# UNITED STATES PATENT AND TRADEMARK OFFICE

APPLICATION NO.	FILING DATE	FIRST NAMED INVENTOR	ATTORNEY DOCKET NO.	CONFIRMATION NO.
10/580,138	05/19/2006	Marco Daneri	163-705	9227
47888	7590	08/11/2011		
HEDMAN & COSTIGAN, P.C. 1230 AVENUE OF THE AMERICAS 7th floor NEW YORK, NY 10020			EXAMINER PRICE, CARL D	
			ART UNIT 3749	PAPER NUMBER
			NOTIFICATION DATE 08/11/2011	DELIVERY MODE ELECTRONIC

## Office Action Summary

## DETAILED ACTION

US 3418062 (Hovis et al) shows:

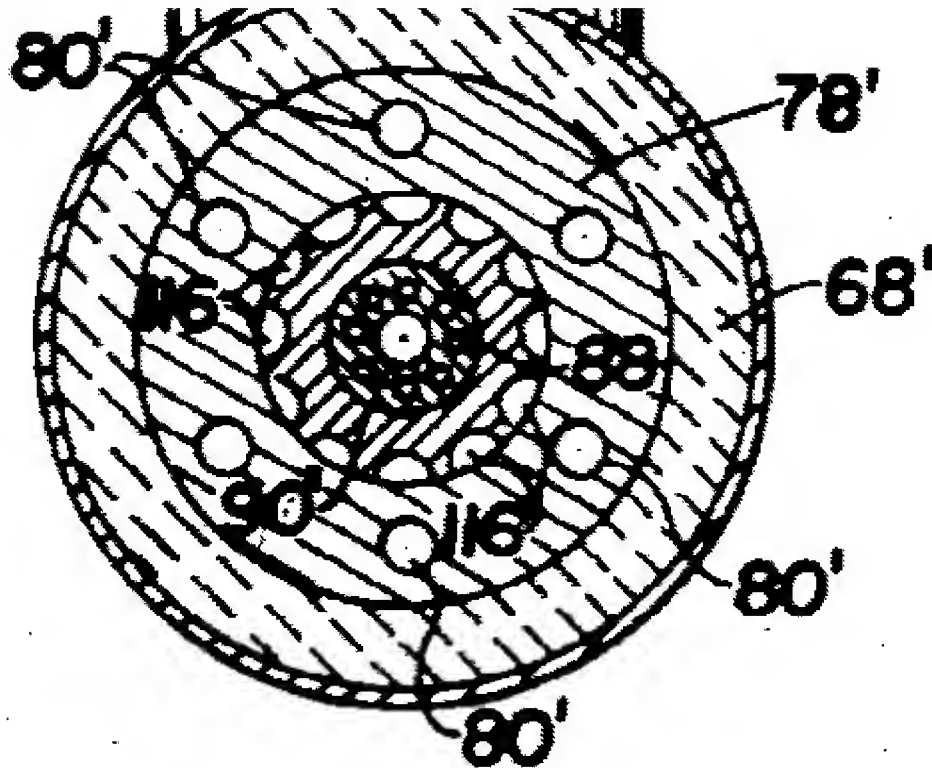
The inner air nozzles (88') of **US 3418062 (Hovis et al)** are deemed the structural and functional equivalent to applicant's "calibrated holes". These holes (88') are located between the inner central lance (92') and the outer side lances (116") in the manner only broadly set forth in the claims.

In regard to **claim 3**, **US 3418062 (Hovis et al)** shows (see the annotated figures herein below) nozzles (88') for the air housed in the second region.

In regard to **claims 7 and 8**, **US 3418062 (Hovis et al)** shows the nozzles of said series of nozzles situated at an equal distance along a coaxial circumference with the inner lance (90', 92') and lying on a base surface of the second region (see the annotated figures herein below).

US 3958413 (Cornelius et al) shows:

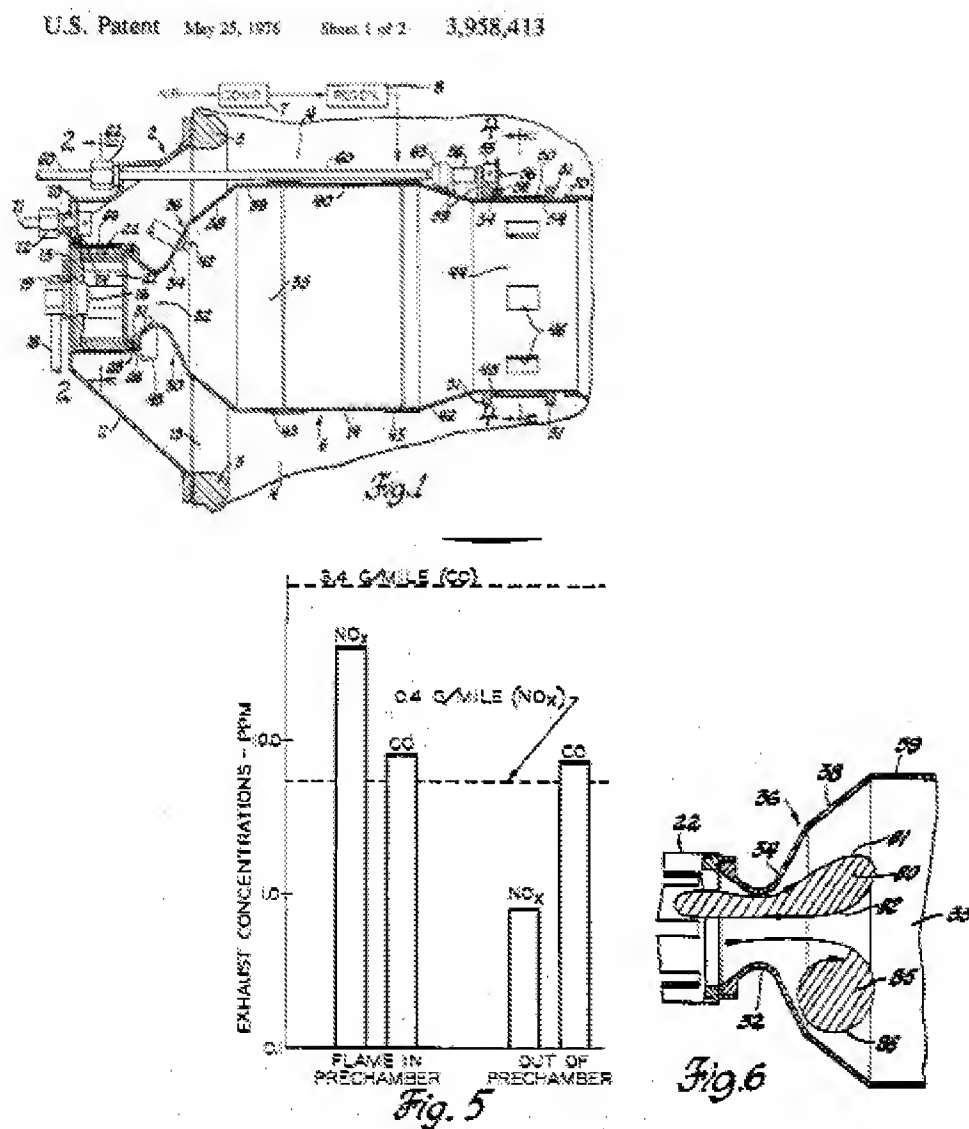
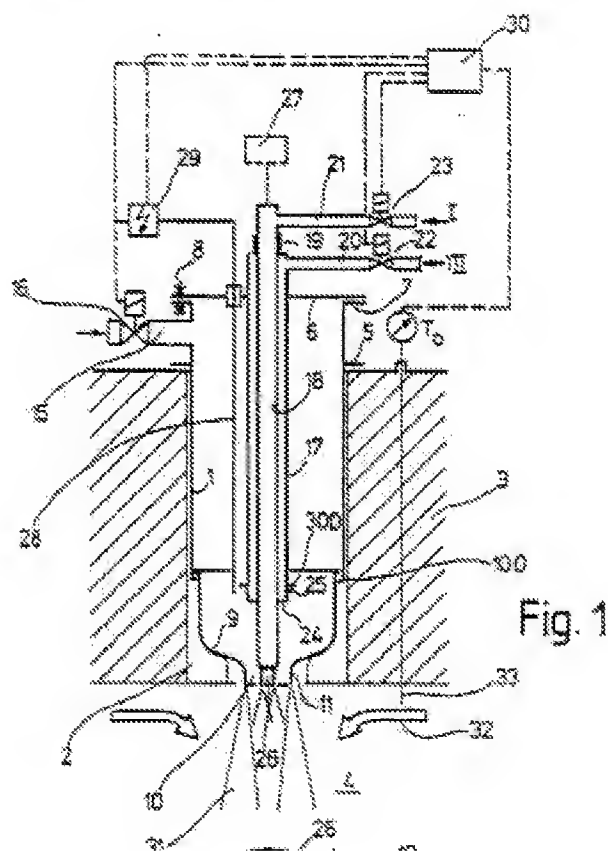
**US 3958413 (Cornelius et al)** teaches, from applicant's same multi-mode flame and flameless burner field of endeavor, means introducing pre-heated air and wherein when operating on the gas regulation system, it is possible to continuously switch from a flame functioning mode of the burner to a flameless functioning mode (i. e. - "invisible burning"), the latter characterized by low emissions of polluting agents.

(24) FIG. 5 illustrates the magnitude of the reduction in the emissions of nitrogen oxides that can be obtained when the flame is forced out of the prechamber while using the combustion apparatus shown in FIGS. 1 through 4 and operated as described above. Note that the vertical scale is a logarithmic scale of nitrogen oxide and carbon monoxide concentrations in parts per million. Concentration data are shown for a typical stabilized combustor operating condition where the flame is either in or out of the prechamber. The broken line identified as 3.4 g/mile (CO) represents the maximum allowable carbon monoxide content, assuming a vehicle fuel consumption of ten miles per gallon. The broken line identified as 0.4 g/mile (NO.sub.x) represents the allowable production of nitrogen oxides, assuming the same fuel consumption. (Highlighting and Underlining Added)

**JP 07-190319** shows:

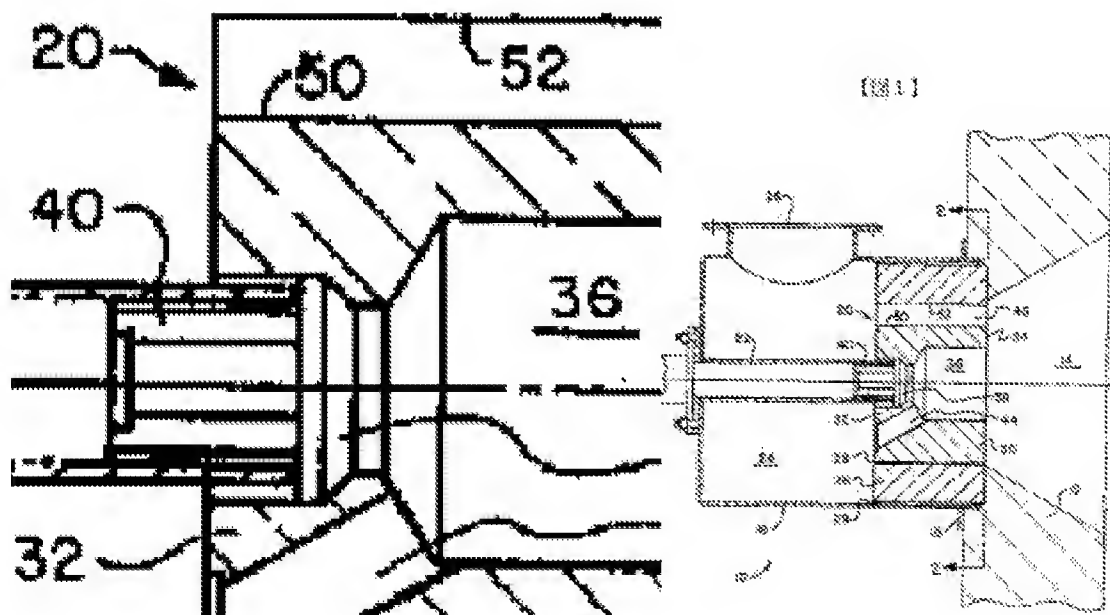
**JP 07-190319** teaches, from applicant same central lance type burner field of endeavor, shows a refractory unit (20) with a free annular crown (i.e. – the free space about the distal end of lance) and being defined between the inner surface of said central hole (generally 38) and the external diameter of said tip portion (the distal end located within the refractory body recess) of the inner central lance, said free annular crown being in communication with said plenum (24) thereby allowing the passage of a sufficient quantity of air there around, which would necessarily act to cool the tip of inner central lance.

In regard to **claim 1**, for the purpose of cooling the tip of the central lance, it would have been obvious to a person having ordinary skill in the art at the time of the invention to form an annular gap about the tip of the central lance located in the refractory body recess of **US 3418062 (Hovis et al)**, in view of the teaching of **JP 07-190319**.

Nummer:  
Int. Cl. 4:  
Offenlegungstag:**DE 197 52 335 A1**  
**F 23 D 14/22**  
27. Mai 1999

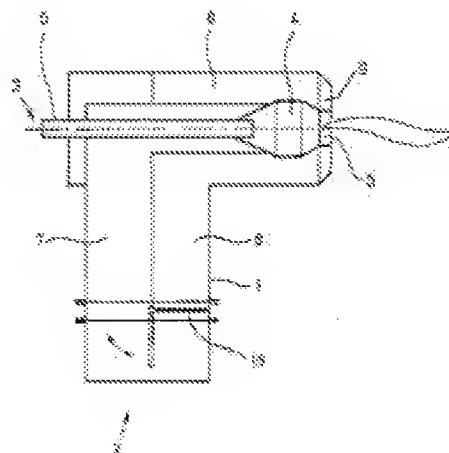
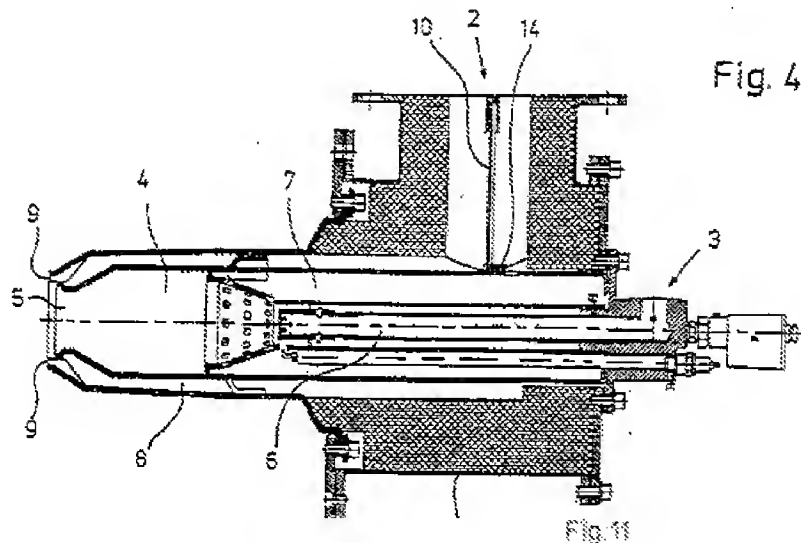
See **DE 19752335 A1** which discloses air-inlet (2) for pre-heatable combustion air:
